Re: State Significant Development SSD-116982991

72 and 82–86 Menangle Road, Camden NSW 2570

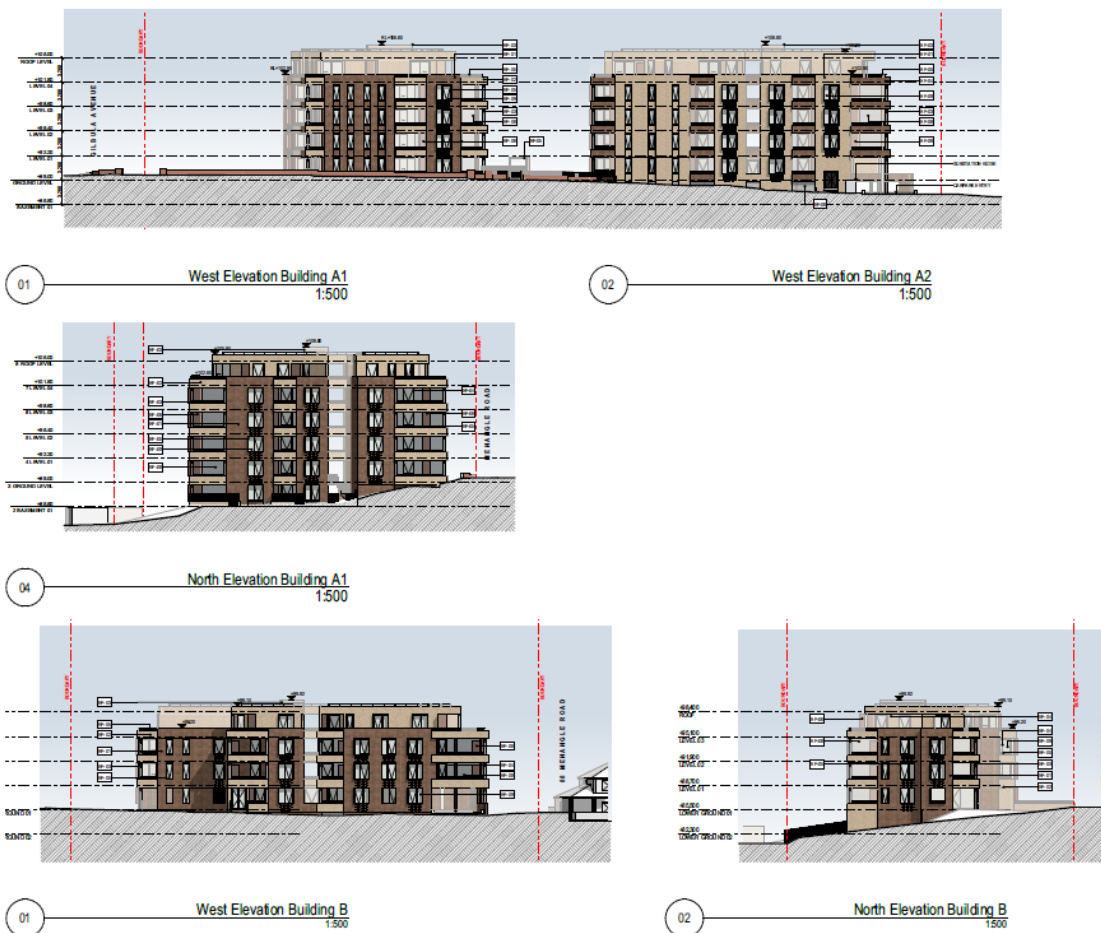
What is the height and scale of the proposed buildings relative to the state-listed buildings of St John's Church Precinct?

Was any lower-scale option tested for this site, and what were the results?

On what environmental planning grounds, given the existing character and heritage significance of the town, was rezoning to R3 to access much greater scale and height than the existing and local desired future character, considered appropriate?
